**Village of Paw Paw
Planning Commission Regular Meeting
Thursday, February 6, 2025**

To: Village of Paw Paw Planning Commission
Date: January 30, 2025
From: Tricia Anderson, AICP
RE: **Special Land Use Request for PUD – Heritage Woods Condominium Development (Tabled 1/2/25)**

HERITAGE WOODS CONDOMINIUMS

1ST FLOOR PLAN
1,152 SQ.FT.

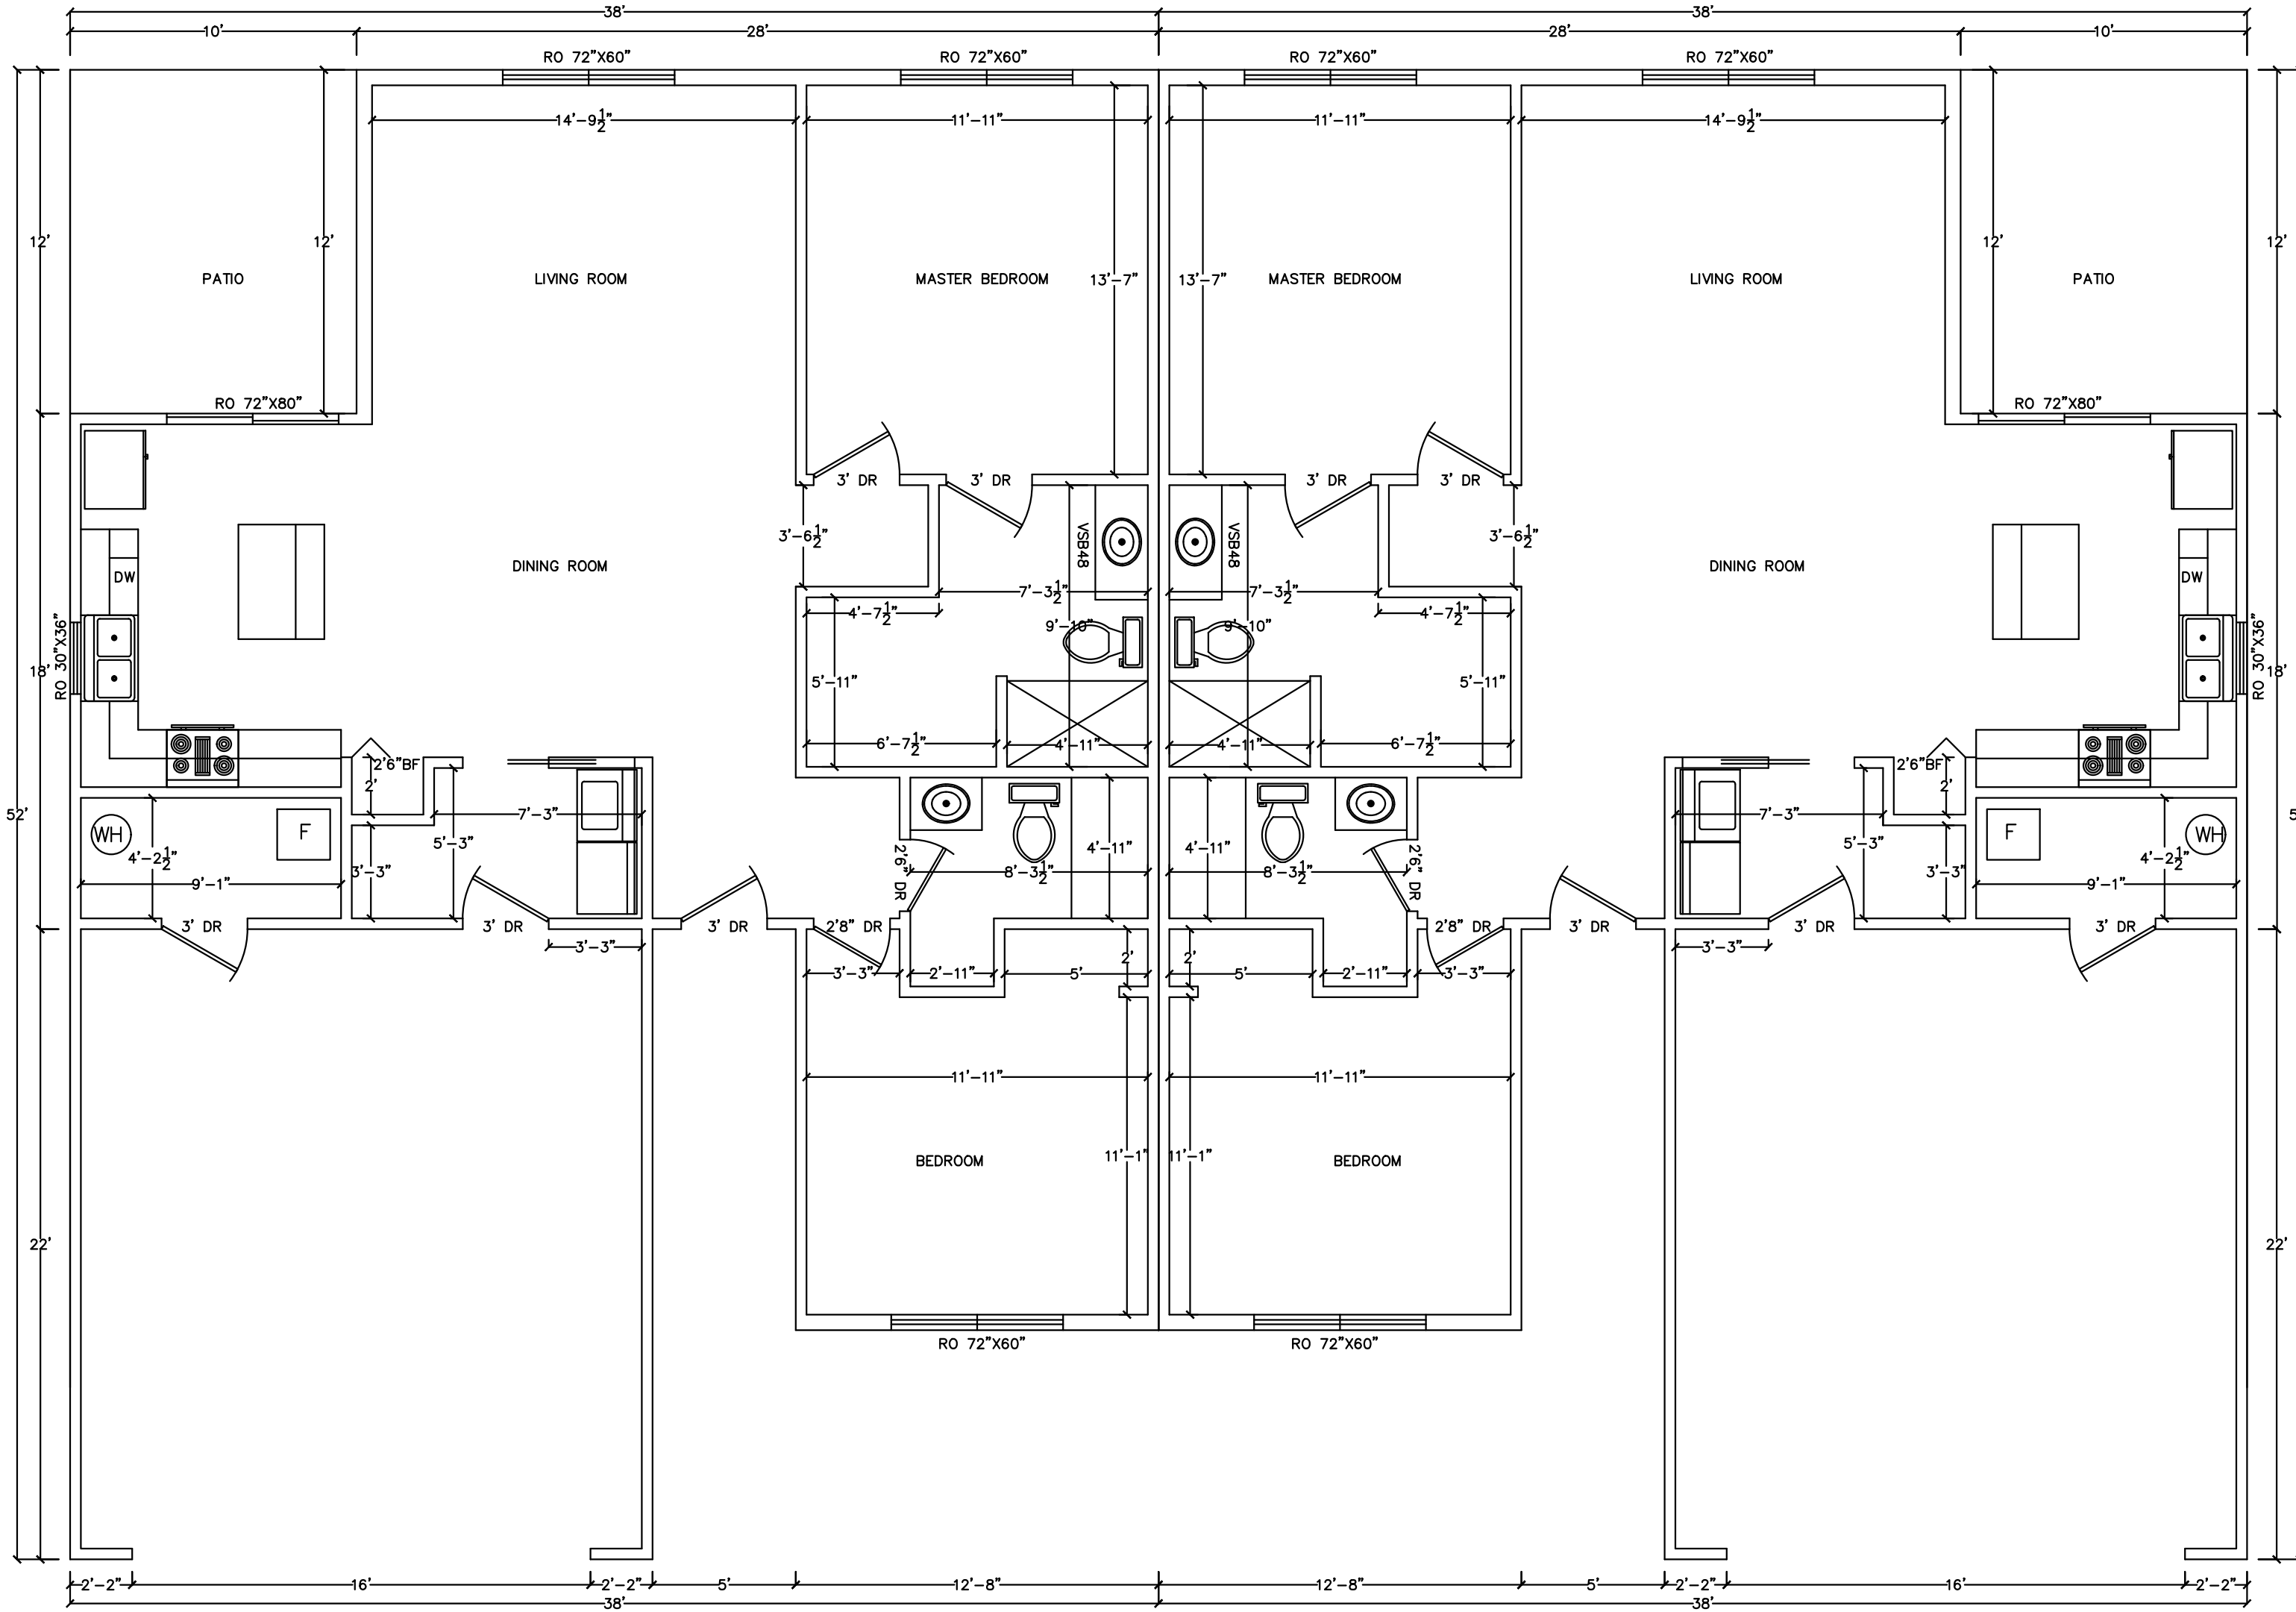
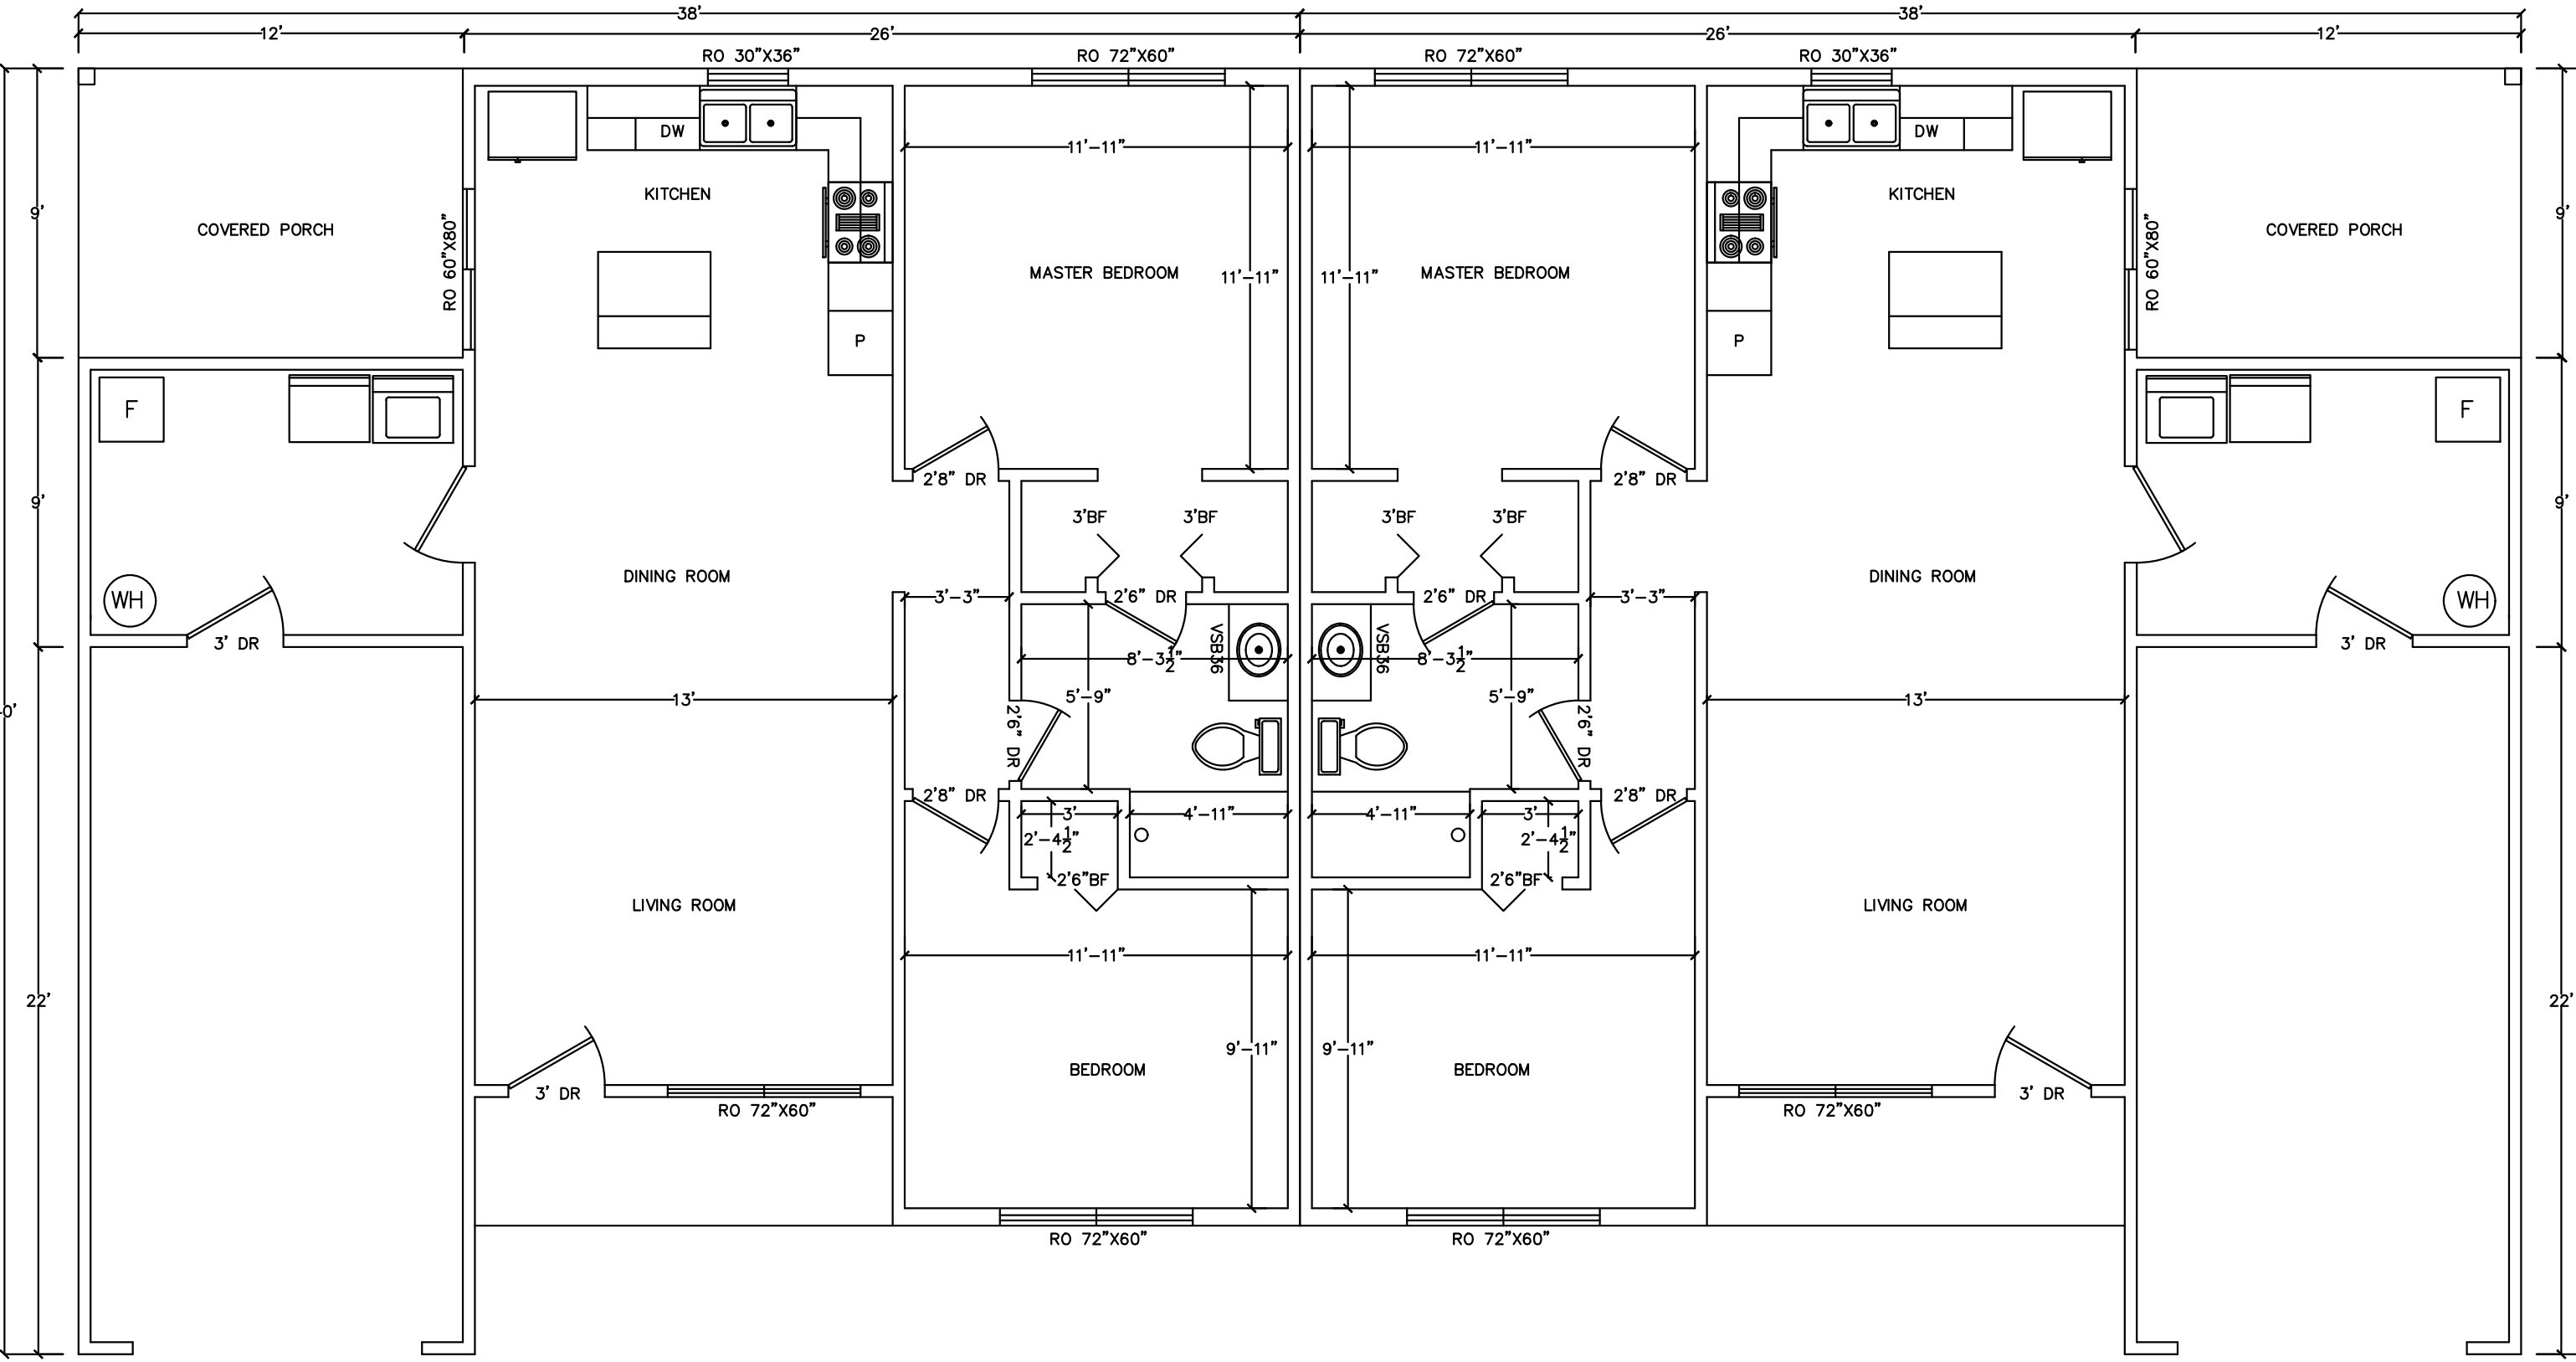
e. The location of each proposed structure in the development area, the use to be contained therein, the number of stories, gross building areas, distances between structures and lot lines, setback lines, and approximate location of vehicular entrances and loading points.	Gross building areas are provided, however, the floor areas within each unit are not. The plan should also provide building dimensions.	Met. The revised plan provides floor areas and dimensions in an additional exhibit.

Remarks: The land and density calculations provided would indicate that these requirements have been met. The PUD allows for flexibility of some of these elements. The minimum floor space for units, however, have not been provided. Section 42-401, Schedule of District Regulations, provides that the minimum floor area per dwelling unit in the R-2 zoning district is 800 square feet, and shall not include areas of basements, breezeways, unenclosed porches, terraces, attached garages, or attached sheds. The applicant has not provided floor plans or dimensions of the buildings or units. This information should be provided in order to determine whether this is met.

This standard appears to be met. The applicant has submitted floor plans depicting floor areas and dimensions.
